Progress Energy Carolinas
**Shearon Harris Nuclear Power Plant
 Units 2 and 3**
Part 2, Final Safety Analysis Report
 New Hill, North Carolina

RAI 2.5.1-12 FIGURE 2

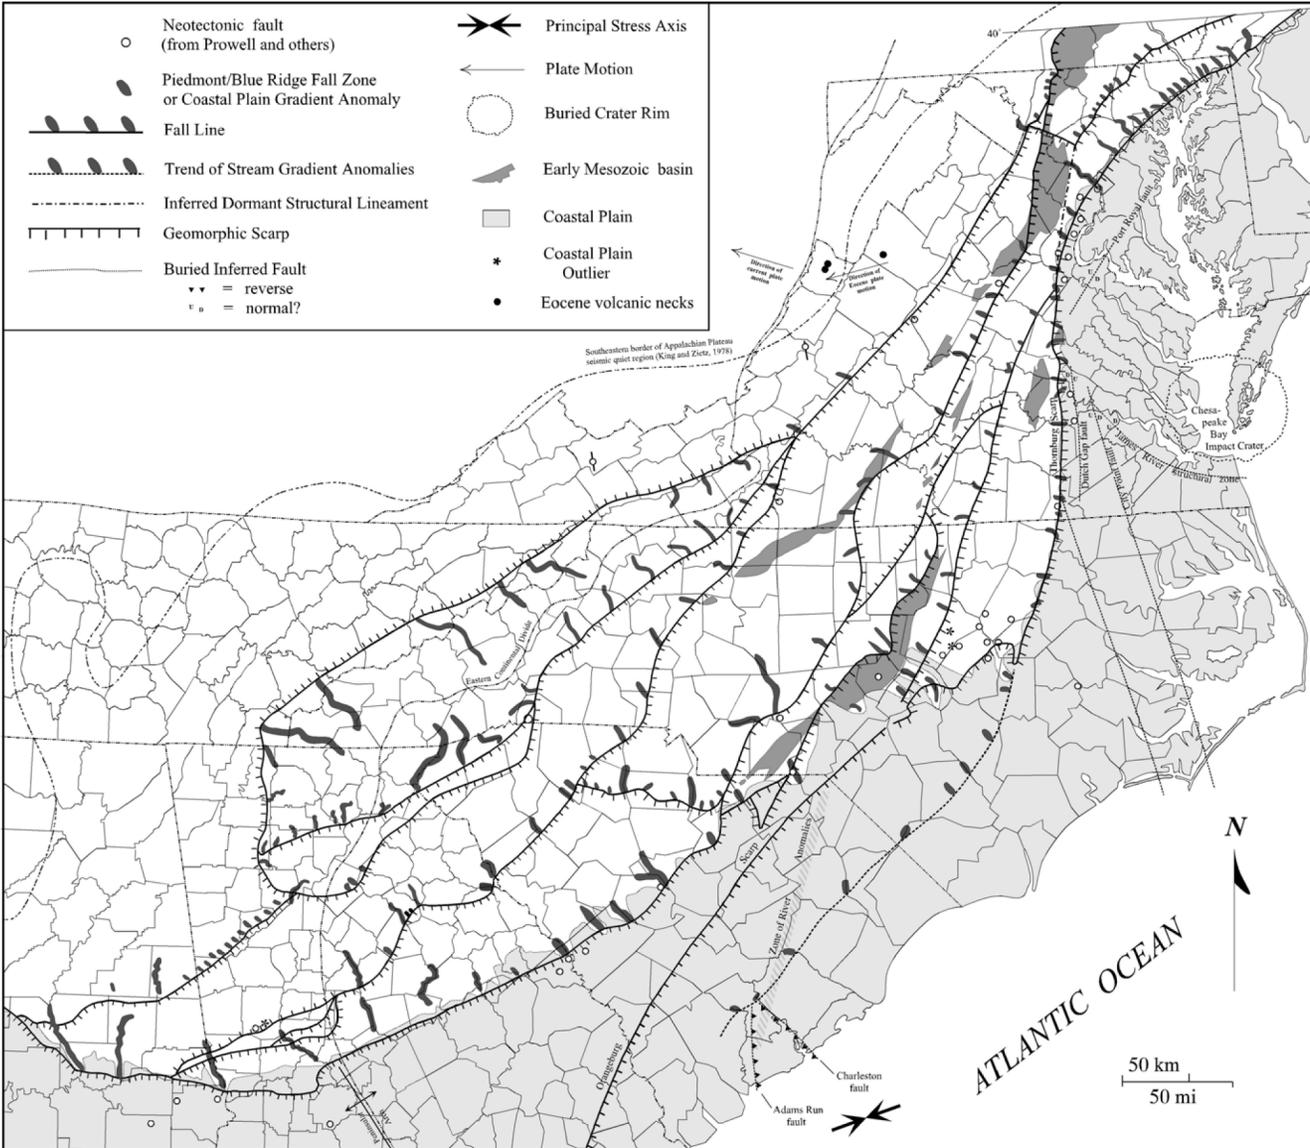
Geomorphic and Neotectonic Features of the Southeastern United States
